ARCHITECTURAL & DESIGN REVIEW APPLICATION

Application: ADR 2016
Property Address: 2138 S Fish Hatchery Road
Review Date: March 11, 2016
Planning Staff Review #1

**American Hindu Assoc– Lot 1 CSM 2141
2138 S. Fish Hatchery Rd
Public Works Review #1**

Open Pavilion
36' x 80' x 11' clear height

**SITE DEVELOPMENT DETAIL
(BALANCE OF SITE UNDISTURBED)
SCALE 1" = 30'**

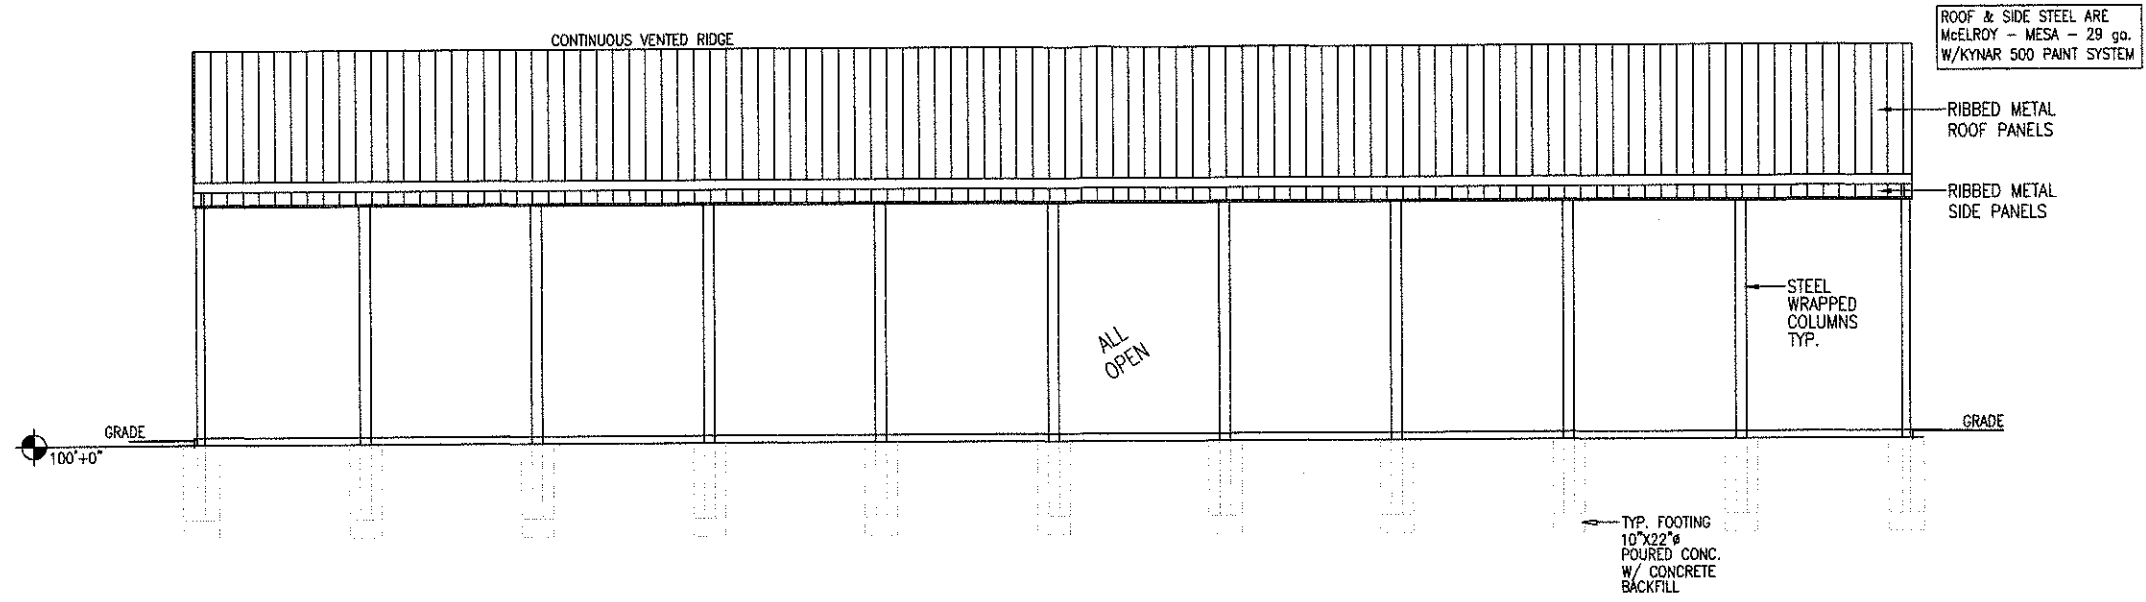
4. Will there be a hard surface walkway or driveway to the building? If so, please show on the site plan. If one is not provided they should check to see if one is required by ADA.

There would be a walkway from the building (south end) to the roadway. This would be concrete. Width of concrete walkway would be determined when site plan is submitted for permit and reviewed by Wisconsin Professional Engineer.

1 NORTH & SOUTH ELEVATIONS
3/16" = 1'-0"

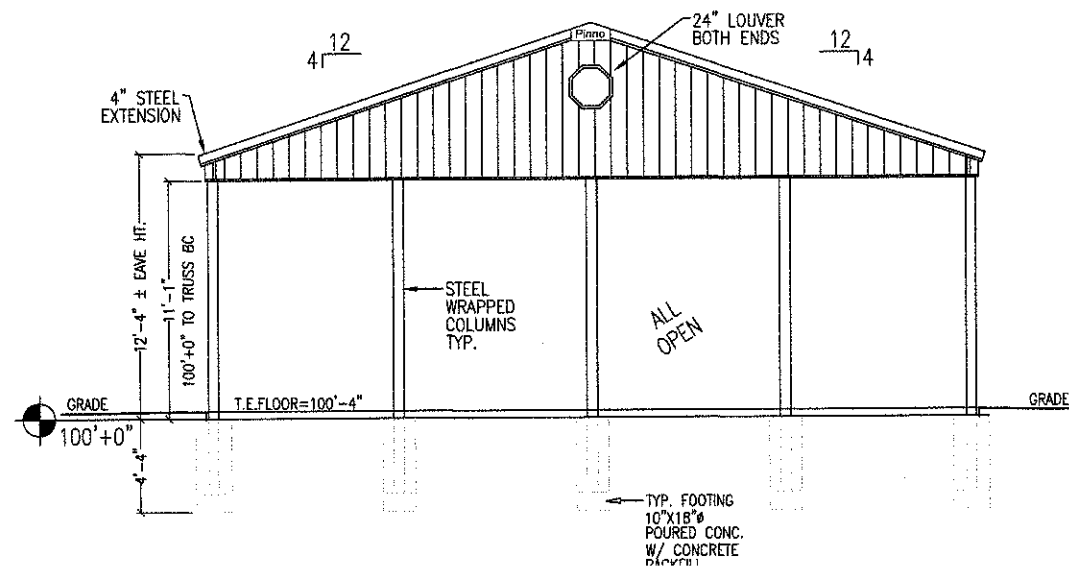
2. Are the colors being used Brite Red and Ivory?

Yes – Roof will be Brite Red with any side or gable steel being Ivory
